**PLANNED UNIT DEVELOPMENT &
SUBDIVISION STAFF REPORT****Date: June 2, 2016**

<u>NAME</u>	Grelot Office Park Subdivision, Resubdivision of Lots 1 & 2
<u>SUBDIVISION NAME</u>	Grelot Office Park Subdivision, Resubdivision of Lots 1 & 2
<u>LOCATION</u>	6740 Grelot Road (North side of Grelot Road, 475'± East of Somerby Drive)
<u>CITY COUNCIL DISTRICT</u>	District 6
<u>PRESENT ZONING</u>	LB-2, Limited Business District and B-1, Buffer Business District
<u>AREA OF PROPERTY</u>	2 Lots / 2.6± Acres
<u>CONTEMPLATED USE</u>	<p>Planned Unit Development Approval to amend a previously approved Planned Unit Development to allow shared access between multiple building sites, and Subdivision Approval to relocate the interior lot line between two legal lots of record.</p> <p>It should be noted, however, that any use permitted in the proposed district would be allowed at this location if the zoning is changed. Furthermore, the Planning Commission may consider zoning classifications other than that sought by the applicant for this property.</p>

SITE PLAN

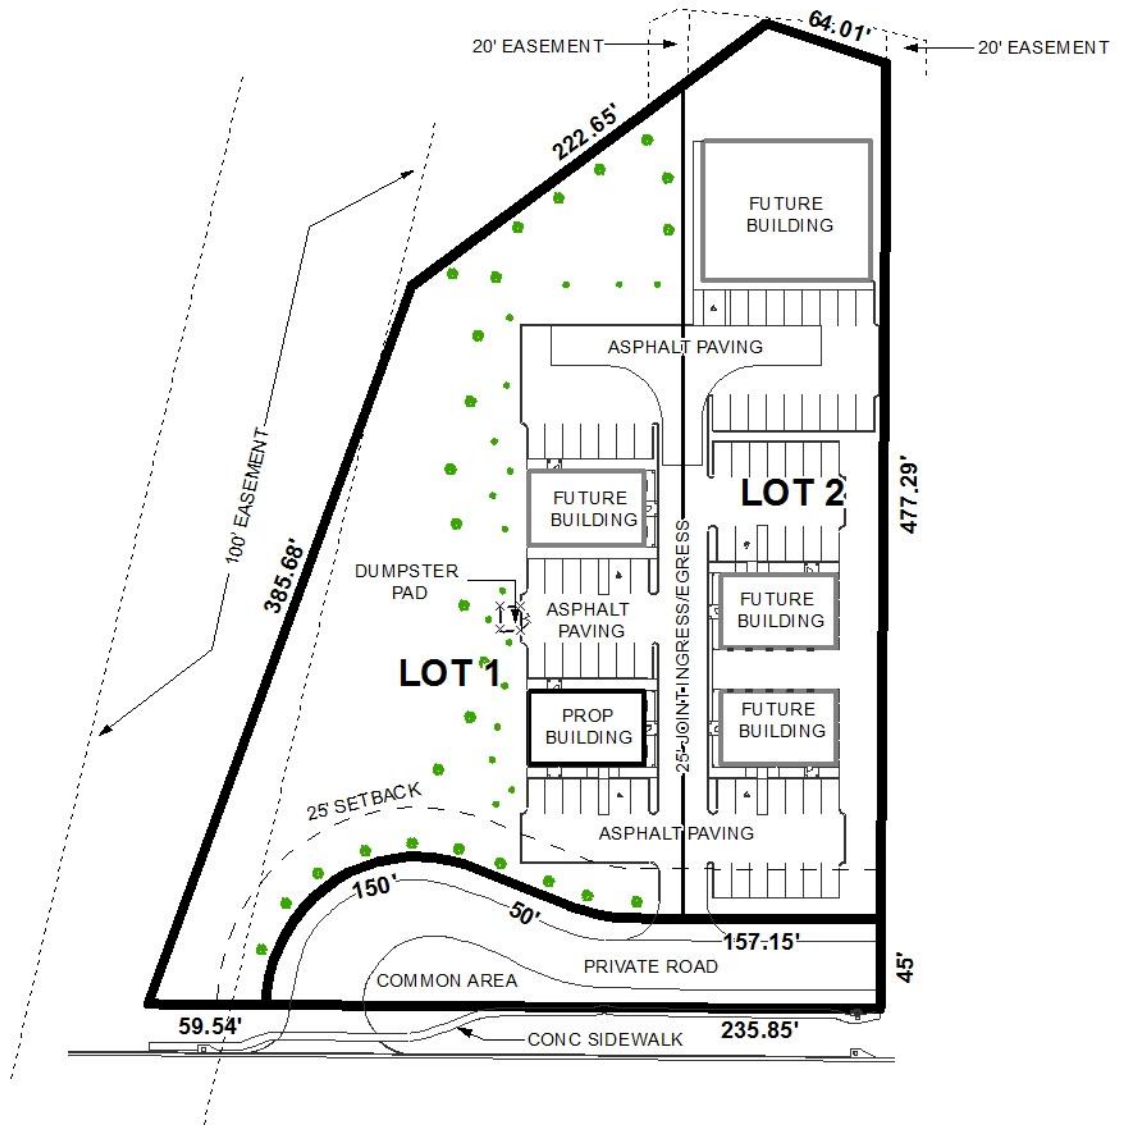
The site plan does have notes relating to required and provided landscaped area, however, these notes state that the proposed Lot 1 is 68,760± square feet, whereas the site plan itself has the size of the lot as 68,640± square feet. According to the proposed Subdivision, the proposed Lot 1 is 68,640± square feet. If approved, the site plan and the preliminary plat should be revised to accurately depict the size of the proposed Lot 1 as well as required and provided landscape calculations so that staff can verify that minimum requirements are met. As the Planned Unit Development is proposed with a common interior property line, staff has in the past allowed these interior property lines not be counted as perimeter lot lines, but rather look at the overall Planned Unit Development (PUD). It should be noted that as each lot is developed, it will be required to come into full compliance with tree planting and landscape area requirements.

There appear to be two conflicting notes on the proposed site plan. Note #6 states “All trees in the first 15’ of 25’ setback to be live oak trees only” and note #7 states “Live oak trees not to be planted within 15’ of overhead utility”. It should be noted that live oak trees are the only overstory tree currently allowed within 15’ of overhead power lines, therefore note #7 should be removed from the site plan.

There are no dumpsters illustrated on the site plan. The applicant should revise the site plan to provide a dumpster, screened from view and in compliance with Section 64-4.D.9 of the Zoning Ordinance, or place a note that curb side pick-up will be utilized.

The site abuts R-1, Single-Family Residential to the East and North. The site plan illustrates a 20-foot landscape buffer/utility easement along the East. It should be noted that per the rezoning conditions, a 20-foot landscape buffer and 8-foot high wooden privacy fence should be provided where the site is adjacent to R-1 property. The site plan also depicts utility and drainage easements along the East of Lot 3 and on the East property line of Lot 1. If approved, a note should be placed on the site plan stating that no structures are allowed in any easements.

- 6) correction of the size of Lot 1 in the “Landscaping Data” information;
- 7) removal of Note #7 stating that “Live oak trees not to be planted within 15’ of overhead utility”;

- 8) revision of the site plan to provide a dumpster, screened from view and in compliance with Section 64-4.D.9 of the Zoning Ordinance, or place a note that curb side pick-up will be utilized;

- 9) a 20-foot landscape buffer and 8-foot high wooden privacy fence should be provided where the site is adjacent to R-1 property;
- 10) placement of a note stating that no structures are allowed in any easements;
